# TECHNICAL INFORMATION

63333

Subject	► Change of Roller and Pin 4 (the components of Retainer Complete)
For Models	► 4304, 4304T, 4304Z, 4305, 4305T, 4306, 4330D, 4331D, 4332D, 4333D, 4334D, DK1032
Country	► All countries
Description	► To increase the durability of Roller against abrasion, Roller and Pin 4 have been changed as illustrated below. Consequently the part number of Retainer Complete has been changed.

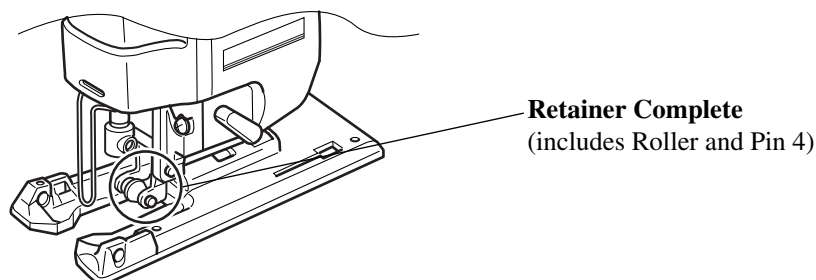
► Current	► New
Roller / Roller Complete	 4mm Roller (322709-7)	 3.969mm Roller Needle Bearing 406 is in the Roller. Roller Complete (152950-6)
Pin 4	 4mm (256667-4)	 3.969mm (268074-9)
Retainer Complete	 Roller Pin 4 (151426-0)	 Roller Complete Pin 4 (152947-5)

Item No.	Current part	Q'ty	I/C	New part	Q'ty	Note
	Roller 322709-7	1	No	Roller Complete 152950-6	1	Interchangeable as a set
	Pin 4 256667-4	1	←	Pin 4 268074-9	1	
See below.	Retainer Complete 151426-0	1	←	Retainer Complete 152947-5	1	Includes Roller Complete and Pin 4.

- 1) Interchangeability mark ; ← means that the new part is substituted for the current.
- 2) The current Pin 4 can be used as a replacement part for 4301V, 4301BV.
